Project: IEEE P802.15 Working Group for Wireless Personal Area Networks (WPANs)

Submission Title: [Comment resolution for CID 400 related to turnaround time]

Abstract: [This document describes the comment resolution for CID 400 related to turnaround time]

CID 400

Turnaroundtime described in D1

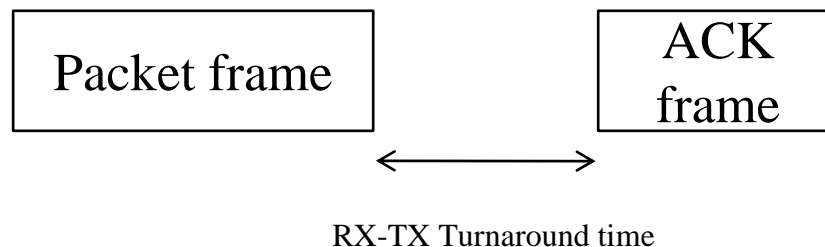
CID	Name	Clause	Subclause	Page	Line	Type	Comment	SuggestedRemedy
400	Cristina Seibert	6	6.5.1	45	24	T	A turnaround time of 0 symbols does not seem feasible. This constant appears to get used in the MAC ACK timing, thus an appropriate value should be chosen that gives the PHY enough time to finish processing and turn around the chains.	Set constant aTurnaroundTime to appropriate value for this PHY

- TX-to-RX turnaround time described in the clause 6.9.1 seems to be a propagation time.
 - So, we think this value might be zero symbol periods.

Procedures transmitting an ACK frame

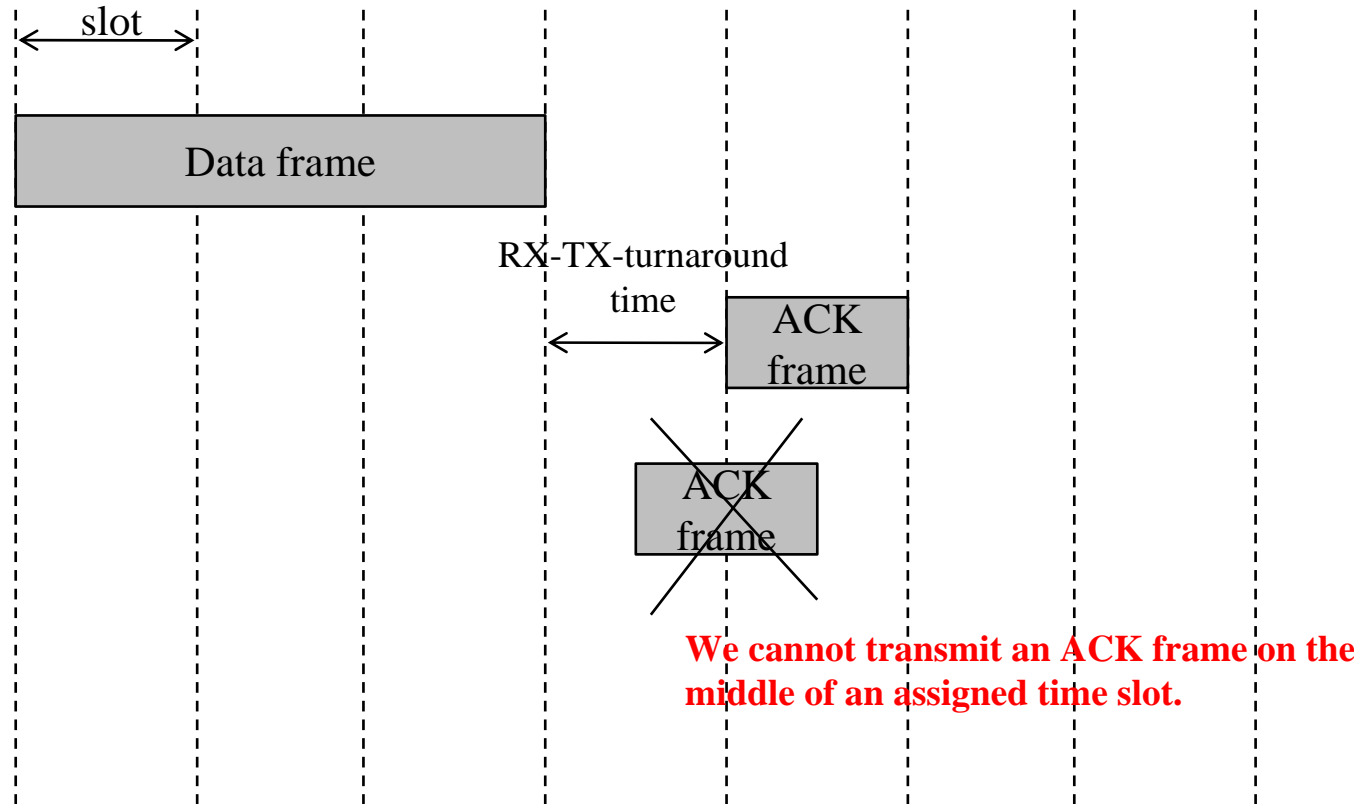
- However, we think RX-to-TX turnaround time is not zero symbol periods.
 - A receiver shall send an ACK frame after receiving a packet frame.
 - So a receiver need time to decide whether the received packet frame has some error or not.

- After receiving a data frame, an Rx will do channel decoding, deinterleaver and CRC checking, and then an Rx will transmit an ACK frame.

- So, an Rx will transmit an ACK frame under the time slot unit system when an ACK frame is transmitted.
- We cannot transmit an ACK frame on the middle of an assigned time slot.
- Therefore, we think that **the use of unit of time slot is more reasonable than the use of symbol when we define the turnaround.**
